APPLICATION
FOR PERCOLATION TESTING AND SITE EVALUATION

RE: Soil Observation Report, 13738 Barberry Way; A544511

PROJECT TITLE
THE BEARES RESIDENCE
13738 BARBERRY WAY
SYKESVILLE, MD 21784

DRAWING TITLE
PERCOLATION CERTIFICATION PLAN

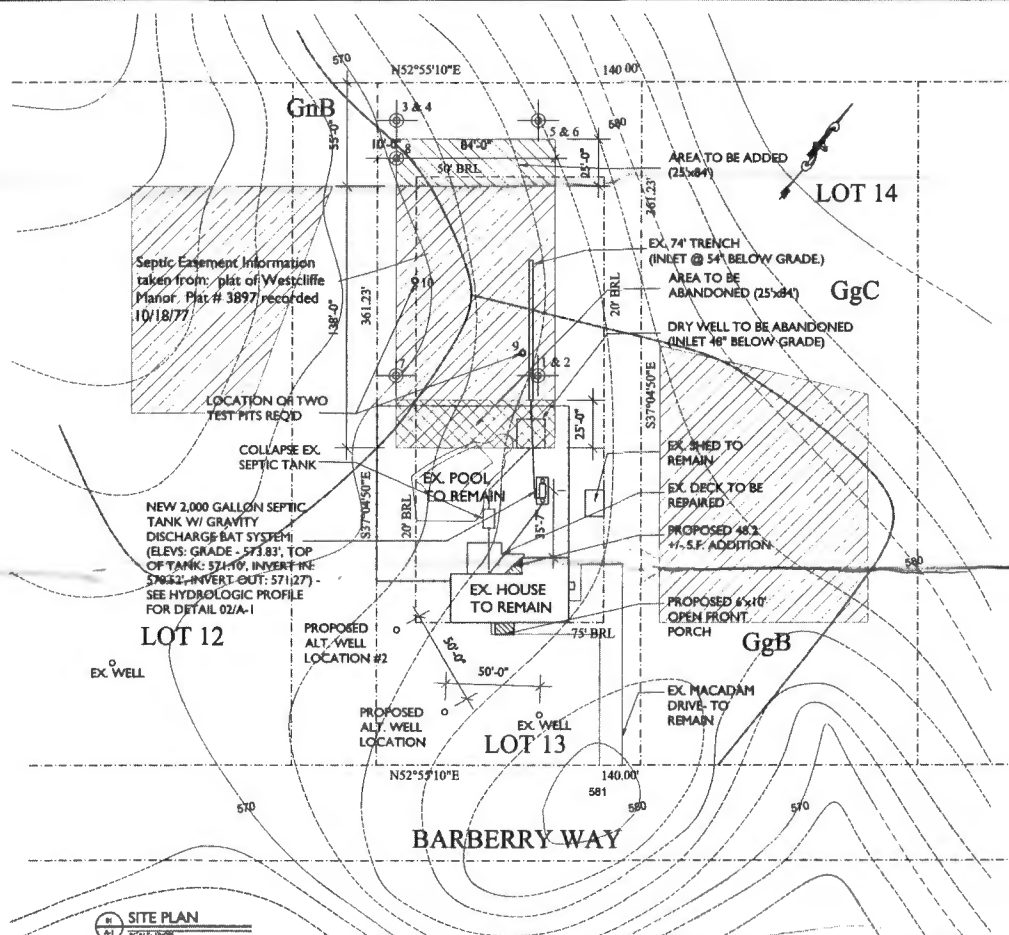
Observation pits for soil analyses were dug on the subject property on February 14, 2013. Two observation pits were dug. The purposes for these observations were (a) to describe the characteristics of the soil profile for the septic reserve area, and (b) to determine that there is a 4-foot soil buffer free of ground water or rock content greater than 50 % beneath the existing seepage pit and trench.

Soil conditions observed at the two locations were satisfactory for onsite wastewater treatment and disposal. Location #9 was dug to 17 feet depth near the end of the 74-foot trench. The depth of satisfactory soil conditions at location #9 shows that the trench (12.5 feet deep) has a 4-foot soil buffer. Location #10 was dug to 14 feet depth. The soil profile is similar to location #9 which indicates soil characteristics are consistent across the existing septic reserve area. Field data collected are shown on Percolation Test Worksheets enclosed with this letter. These data may be utilized to design trench distribution systems when the existing trench fails.

The existing trench (as constructed) has absorption area of 740 square-feet. At a loading rate of 1.2 gallons per day per square-foot, the trench may support the estimated discharge from a 6-bedroom residence (which requires 750 square-feet of absorption area at 1.2 gallons per day per square-foot).

The existing seepage pit had 450 square feet of absorption area when constructed. The solution in the seepage pit is murky and black, and the level appears to be at the outlet elevation. Due to these conditions there is no credit given for absorption area in the seepage pit.

The existing septic tank, 1250 gallon capacity, was installed to meet Code of Maryland requirement for a 4-bedroom residence. As the planned addition includes a bedroom, the septic tank capacity must be increased. Therefore an upgrade is needed, and a Best Available Technology (BAT) unit of your choice is to be installed.

Prior to Health Department approval of the building permit application to increase the size of the residence, the following items must be completed:

1. A site plan for installation of the BAT unit must be submitted and approved by the Health Department. (A plan has been submitted and will be reviewed.)
2. After signature by owner and by the Health Department Approving Authority, an Operation and Maintenance Agreement for the BAT unit must be recorded at Howard County Land Records. The BAT installation permit may be released when the Health Department has a copy of the receipt from Land Records, indicating that the agreement had been submitted for recordation.

3. A BAT unit must be installed and connected to the existing 74-foot trench.
4. The existing septic tank and the existing dry well are to be pumped free of solution, the tops removed and the voids filled clean earth materials.
